# Accessibility Survey

## City of Downey Planett Avenue - 7th Street to Cul-De-Sac

Prepared By  
**Disability Access Consultants**  
(800) 743-7067

## City of Downey Planett Avenue - Orange Street To Cul-de-sac

#### Light Pole North Of Orange Street @ 33.925494699344, -118.140417337418

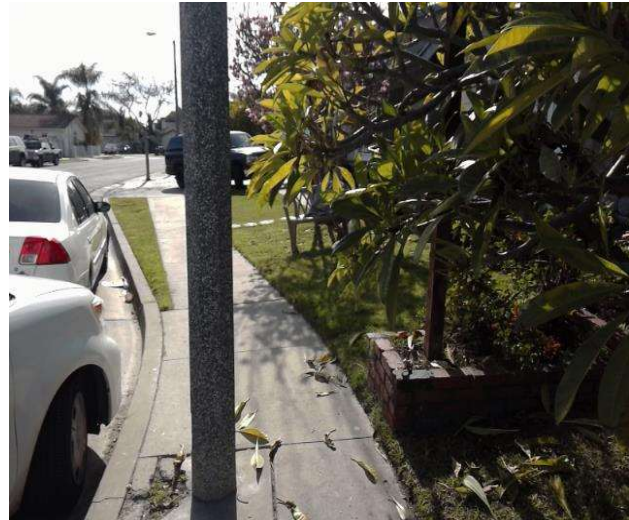
Sidewalks , Hazards & Gratings : Sidewalk Width at Obstruction

Sidewalk width at the obstruction is not compliant.

**On-Site Finding** 32.50 inches

Sidewalk width at the obstruction shall have the recommended value.

Recommendation At least 48.00 inches
